Service Manual

NISSAN Motor Genuine
 2DIN HDD Navigation

The original model of UQY7813/4/5/6,UQY7823/4/5/6 is UQY6102. This additional service manual is designed to be used together with the service manual of UQY6102.

ASSEMBLY DRAWING

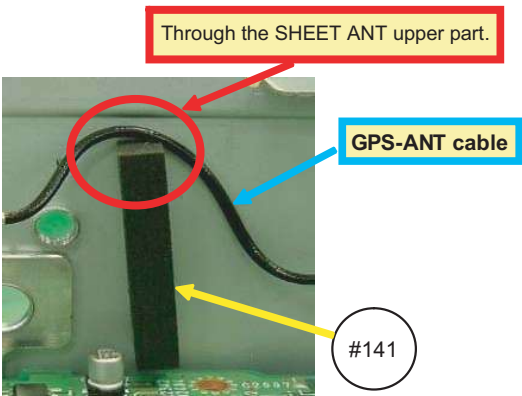
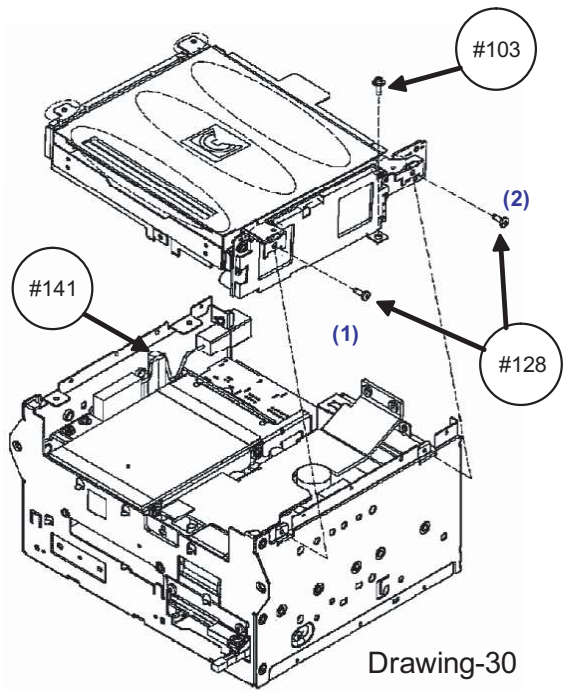
Please confirm it about the additional part (#141) in the following
ASSEMBLY DRAWING and ASSEMBLY PROCEDUER.

PROCEDURE	NOTICE
3.Stick the(#141)ANT sheet on the processed AUDIO PWB ASSY (Drawing-30) and lay out GPS-ANT cable.	※Through the SHEET ANT upper part. (Drawing-24)
